HISTORIC PRESERVATION ADVISORY COMMITTEE
MEETING
(Action) Meeting Minutes
December 7, 2022

PLANNING ACTION: PA-T1-2022-00199

SUBJECT PROPERTY: 748 Siskiyou Blvd

Comments from Dale Shostrom

EAST ELEVATION 2
3/16" = 1'-0"

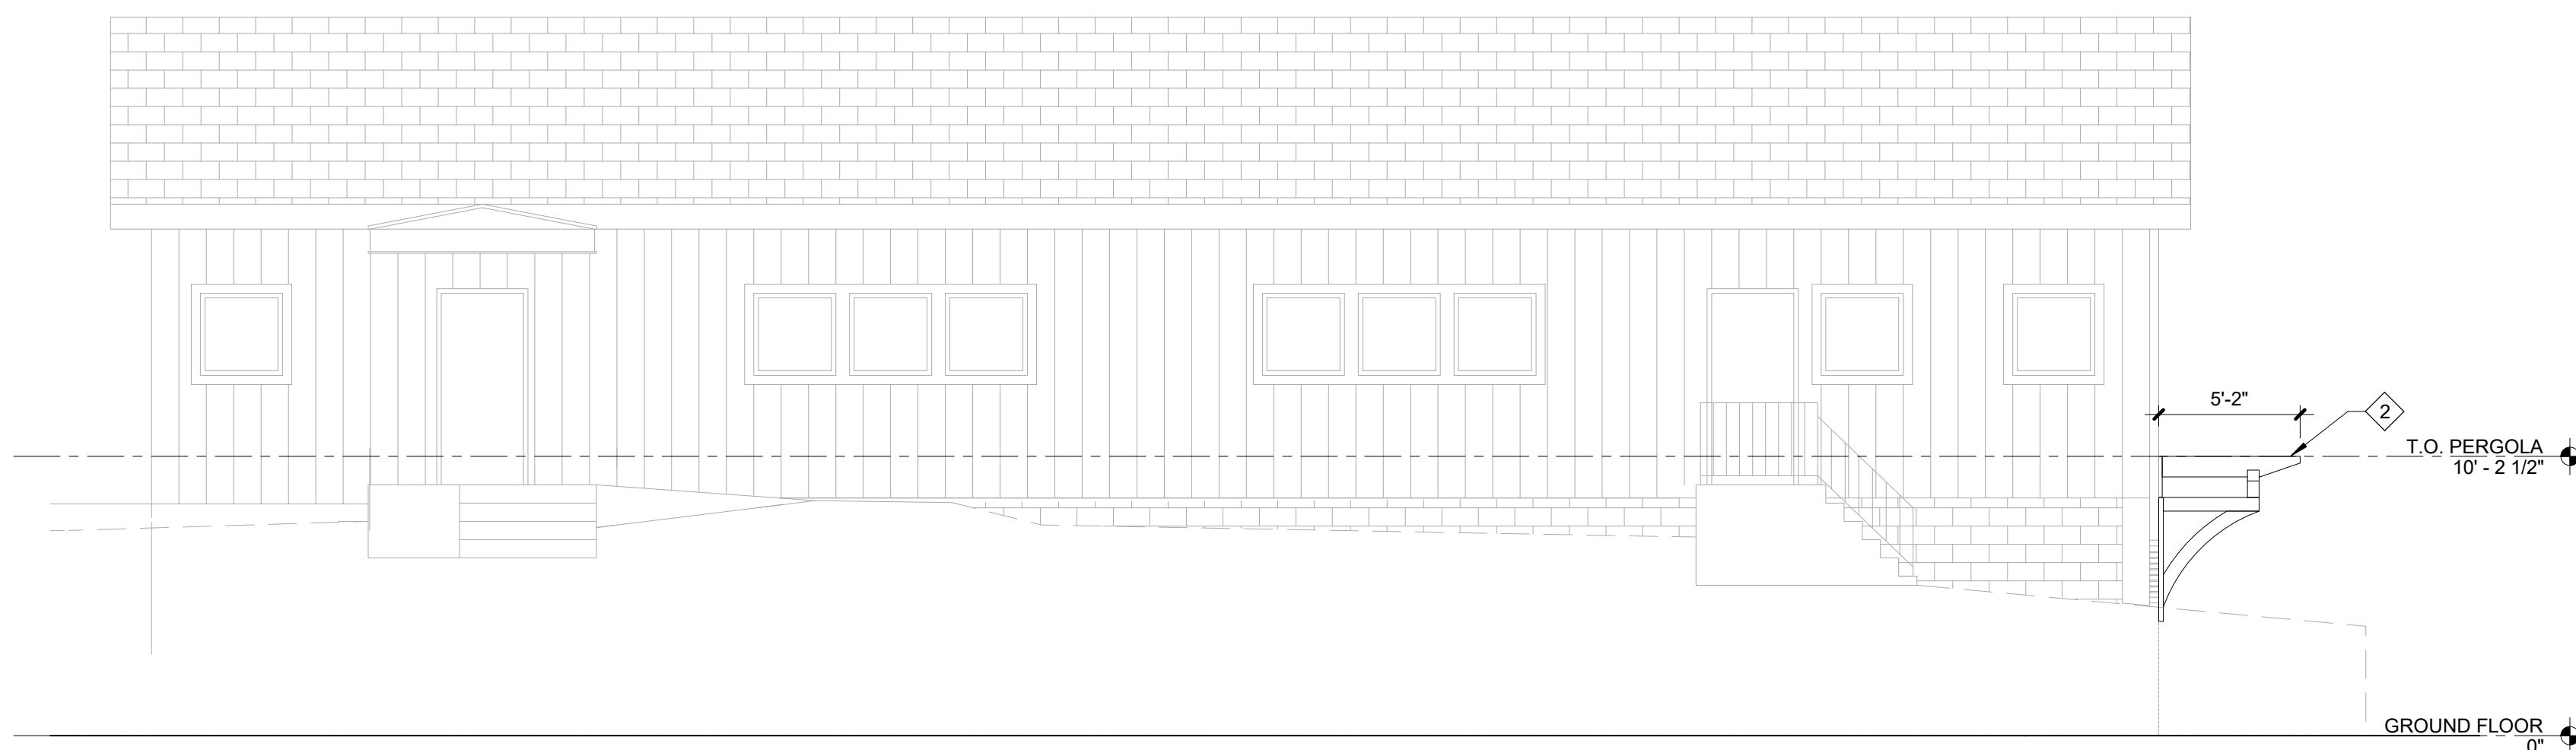
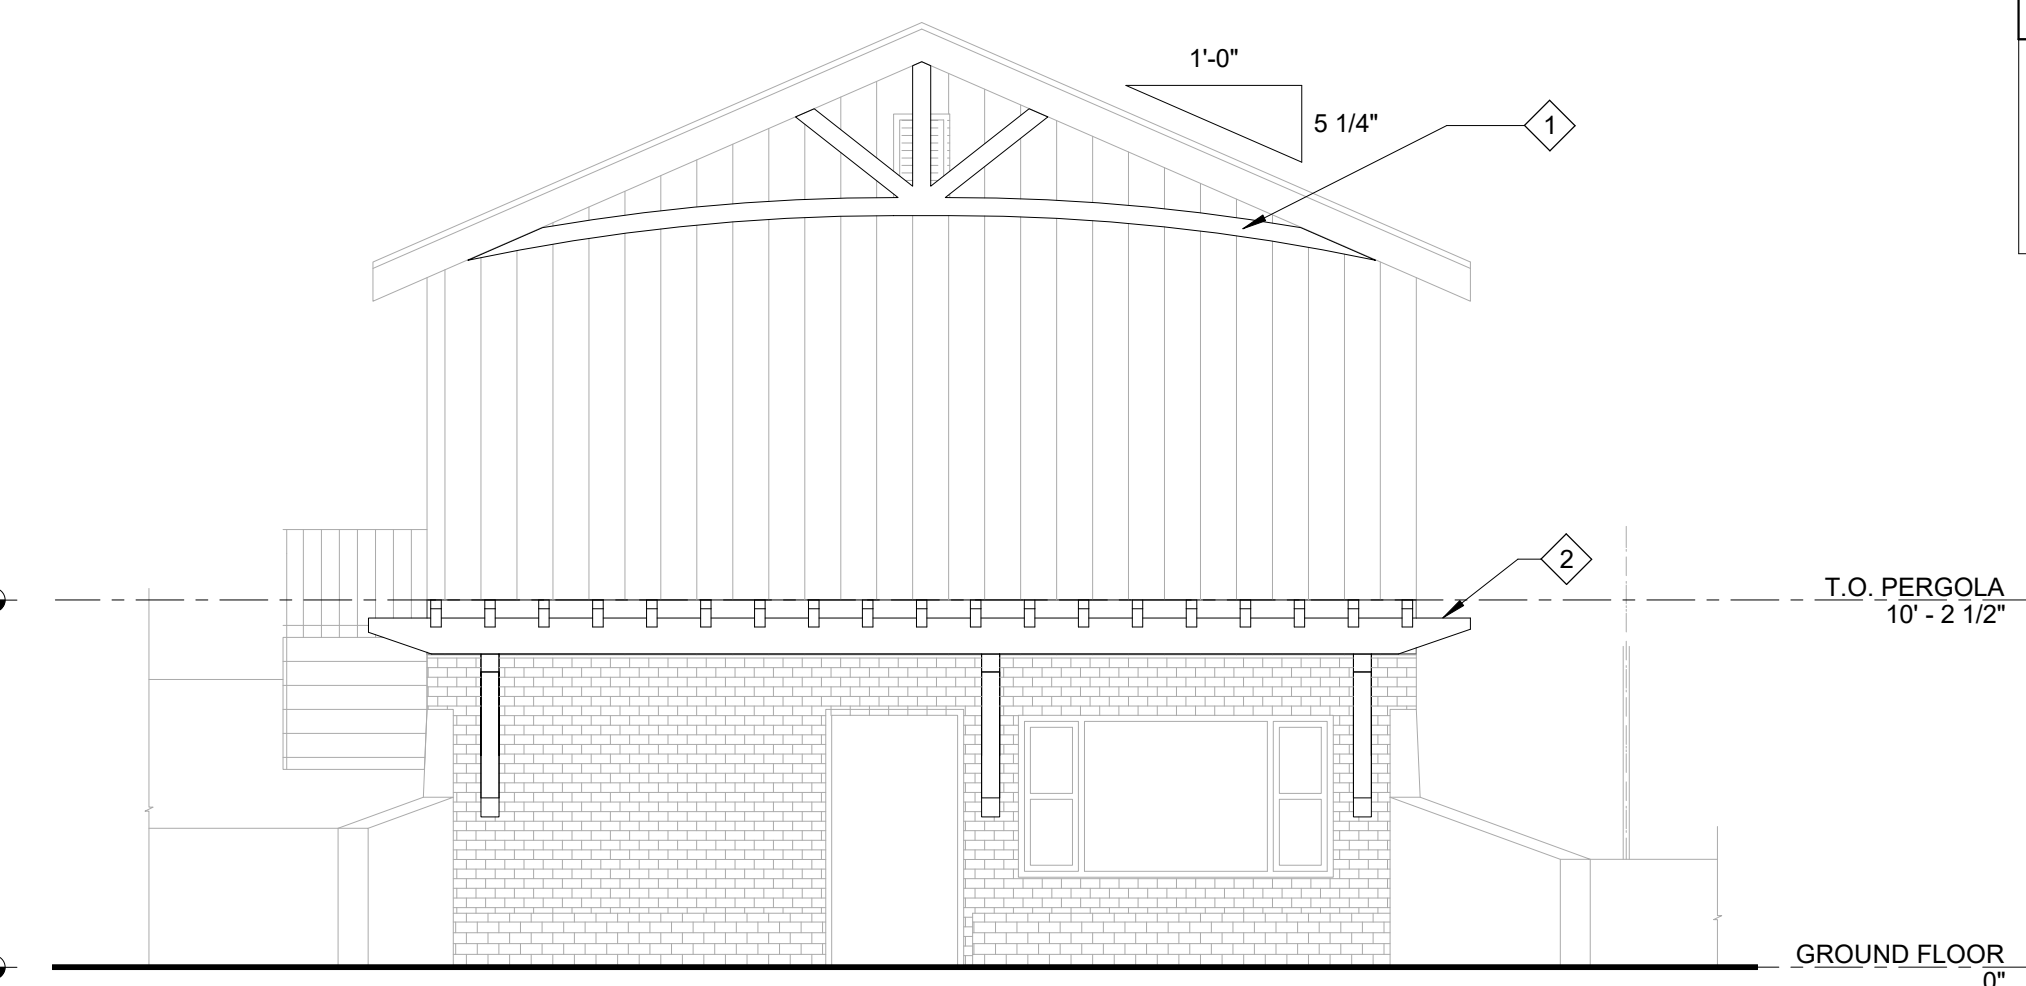
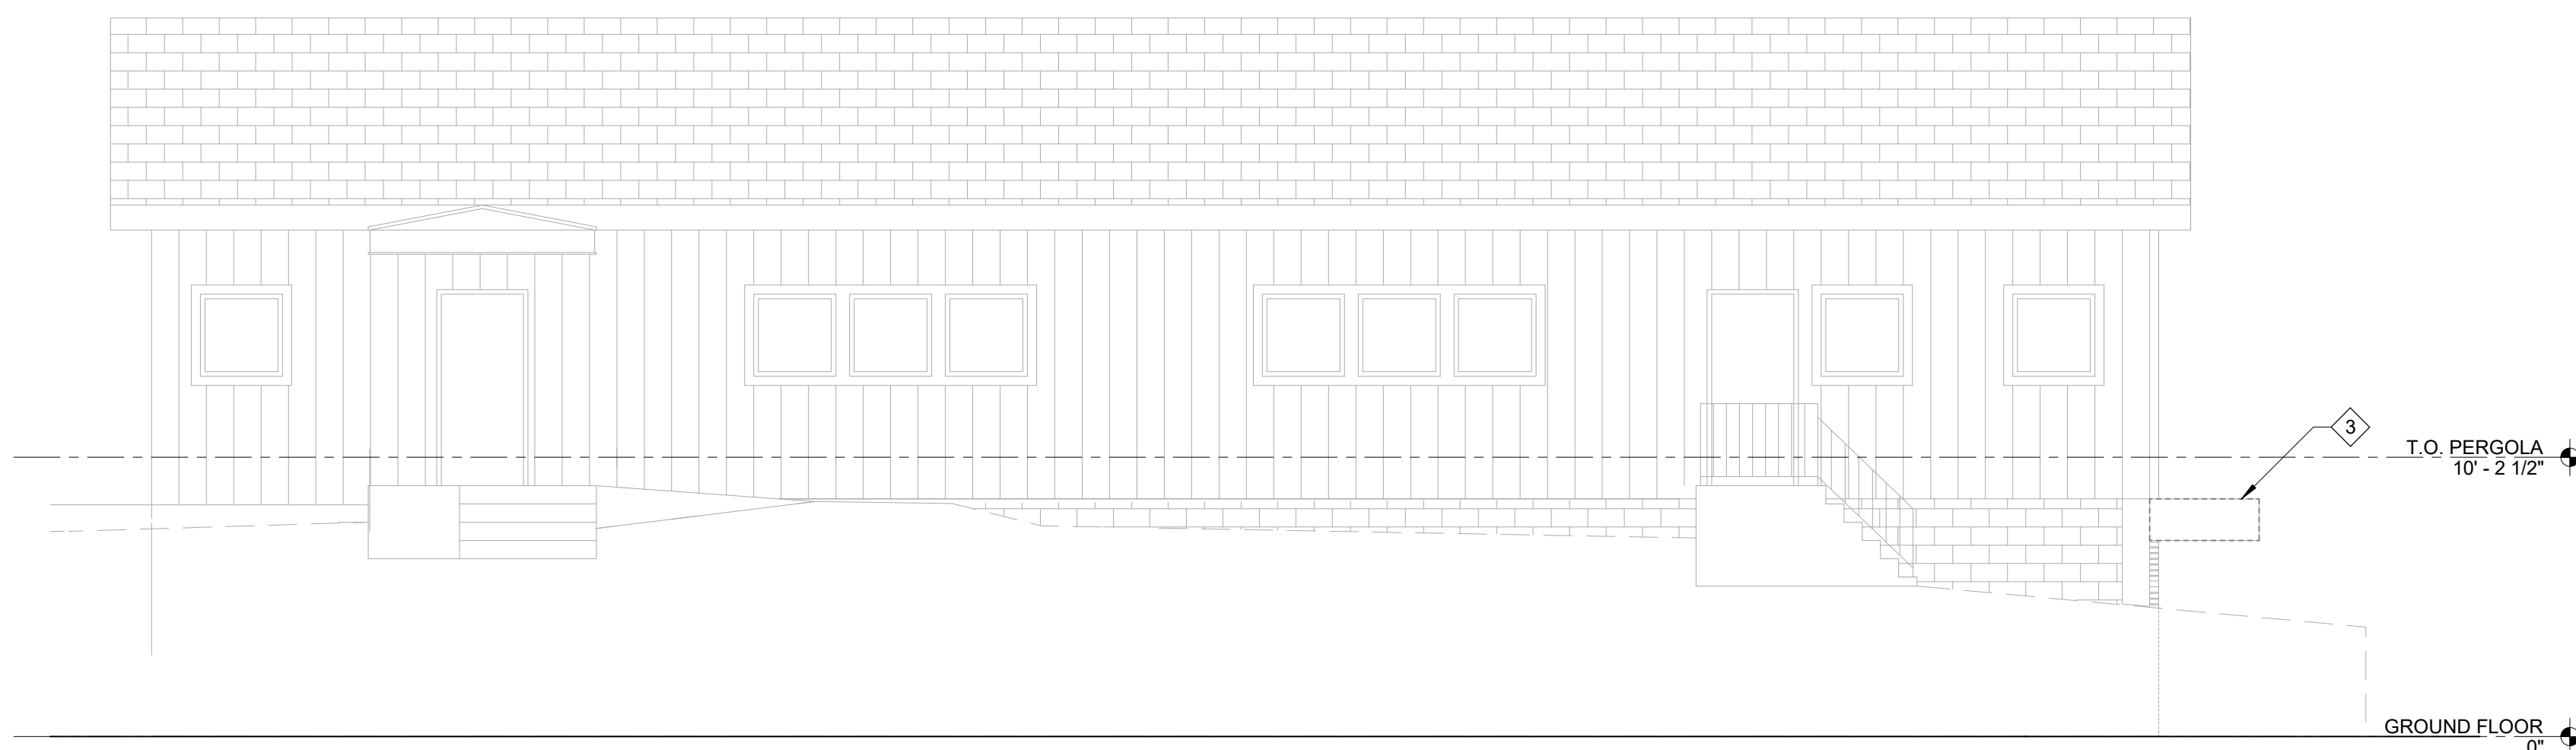
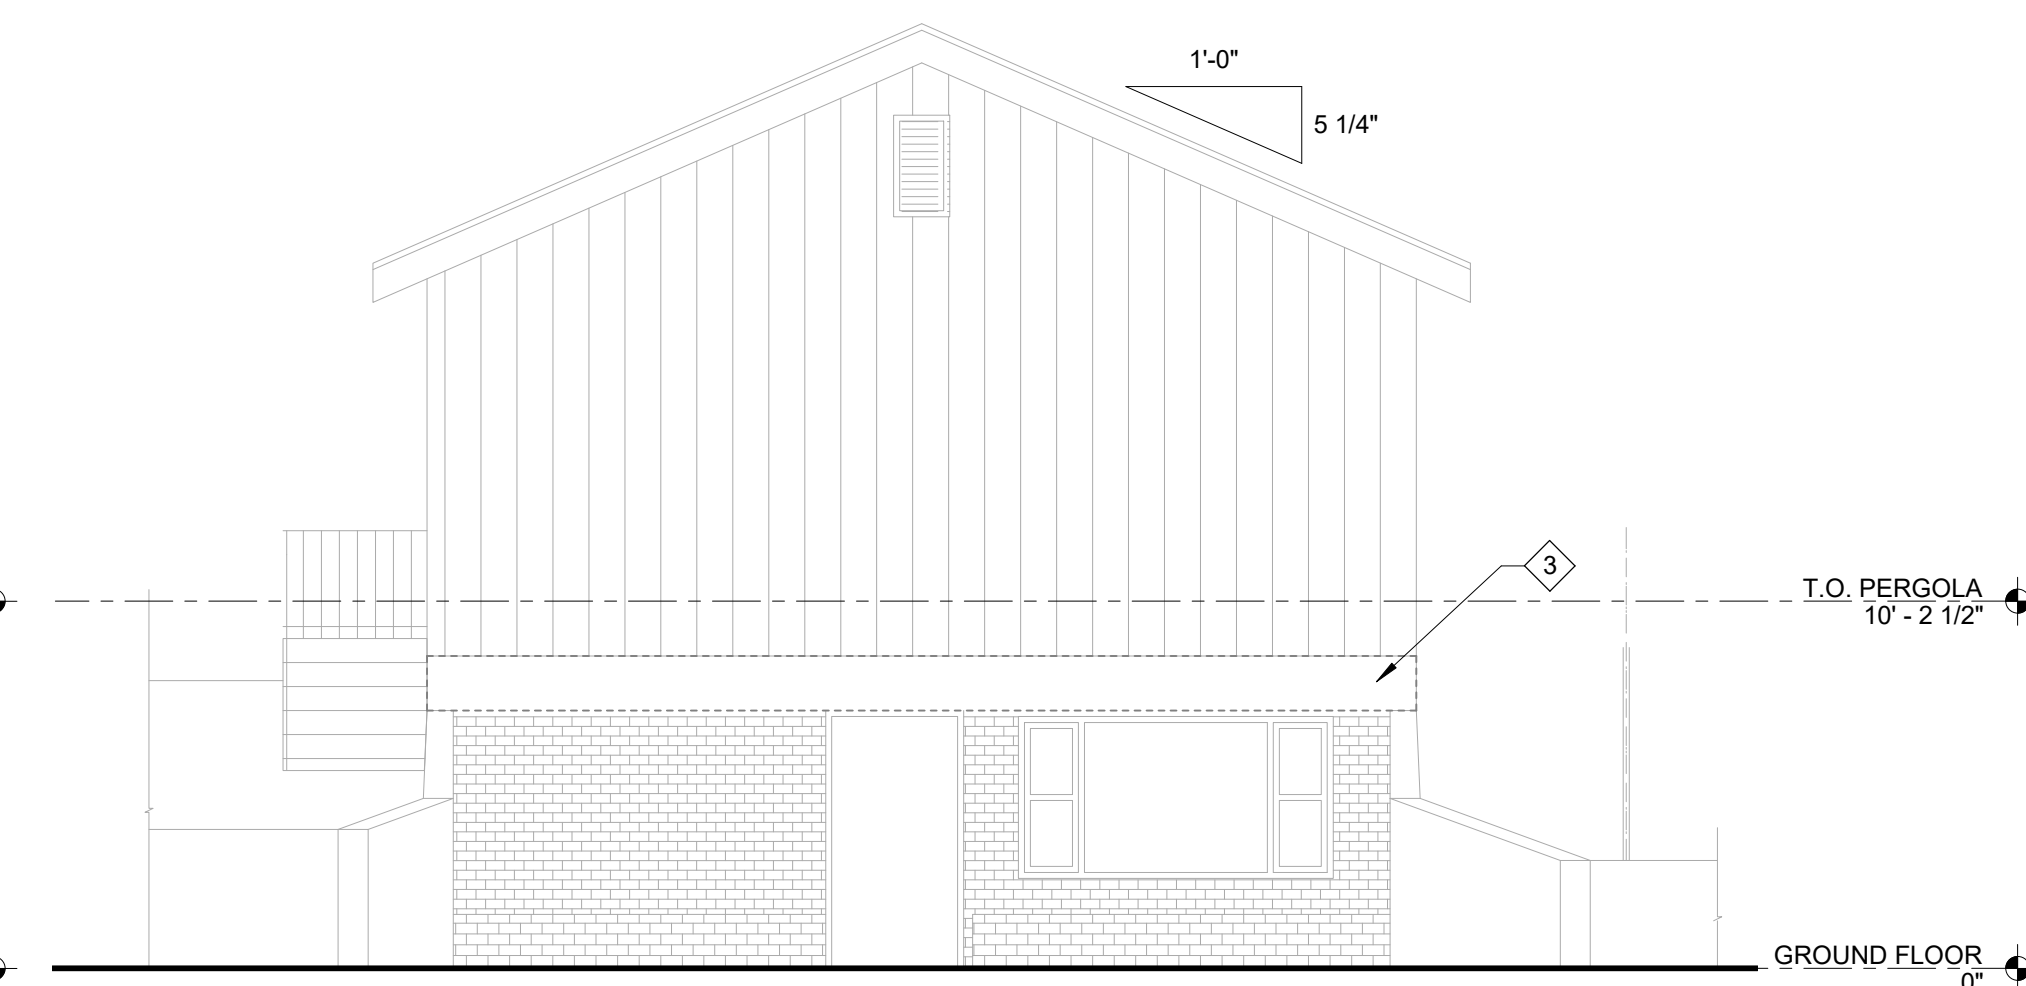
Commissioners discussed potential design changes which might better address compatibility with Historic District Development Standards including reducing the scale/size of structural members of the pergola, adding windows to the Siskiyou Boulevard-facing wall above the pergola, and retaining the existing four knee braces either in combination with or in lieu of the proposed new arched gable element.

Ultimately, the Commission recommended that the design be approved as presented and advised the applicant to consider the addition of three windows in the wall face above the pergola.

Entry Door: The proposed entry door facing Siskiyou Blvd. is called out as a storefront door but does not specify what that is exactly. If what is proposed is metal storefront with narrow metal styles and rails, a modern commercial look, I would suggest a full light wood door, or one that matches main entry which is a small pane true divided lite wood door, both would be more compatible to the neighborhood and just as functional. It would also be more consistent with the very attractive proposed wood beam pergola and gable end in treatment details.
